# KEACH POND VIEW SUBDIVISION WOODSTOCK, CONNECTICUT

## EASTERN CONNECTICUT ENVIRONMENTAL REVIEW TEAM REPORT

REPORT #616

NOVEMBER 2007

Figure 4. Flat area near base of slope adjacent to parcel A. Although not shown, slope is very steep uphill (on the left). Note that slope again steepens downhill. This is interpreted as the toe of an inactive slump.

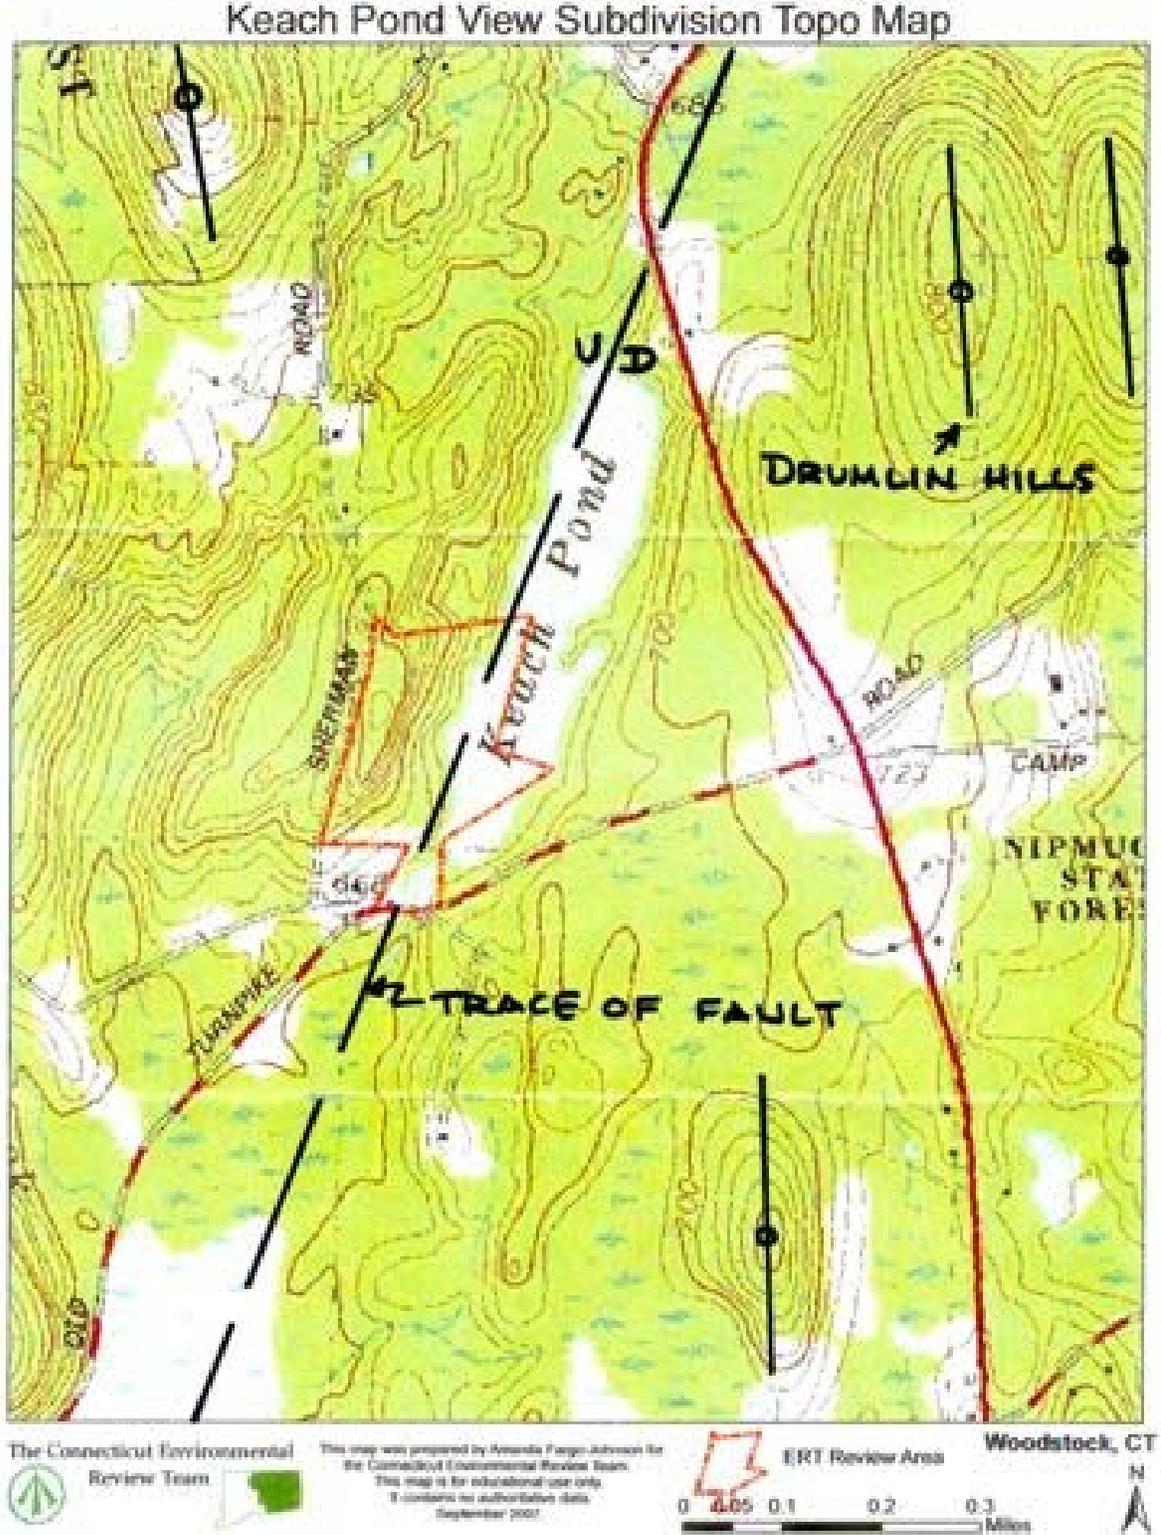
Evidence for past landslide activity includes the remnant of a head scarp at the top of the slope on proposed lot #5 (or #4?). (Figure 3) and a roll-over toe observed in several places near parcel A at the base of the slope. (Figure 4) Past down-slope movement may have occurred when the land was clear-cut.

Figure 5. Low outcrop of calc-silicate gneiss of Bigelow Brook Formation exposed near rear of proposed lot #4. Out crop is 2-3' high. Note lack of apparent fractures in outcrop.

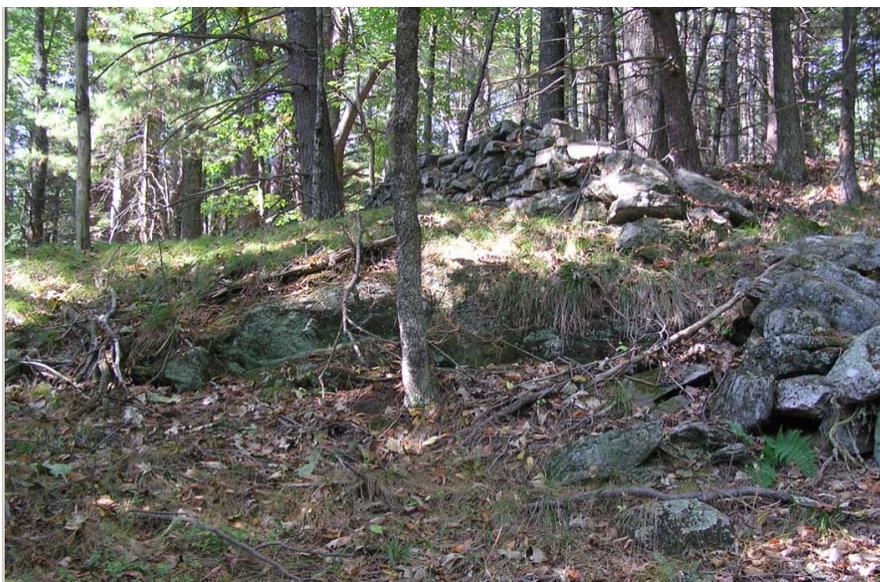
The outcrop observed during the ERT field review was poorly fractured (Figure 5). Foliation parallel fractures dip into the hillside, away from Keach Pond. If groundwater recharge occurs beneath the soils, it would flow away from Keach pond in the foliation-parallel fractures. In addition, Pease (1972) shows south-dipping east-west fractures at numerous places on his map (one at an outcrop immediately south of the proposed subdivision). These cross-cutting fractures are important. If groundwater recharge to the bedrock occurs beneath the soils on this parcel, the east-west oriented fractures will allow that water access to Keach Pond.
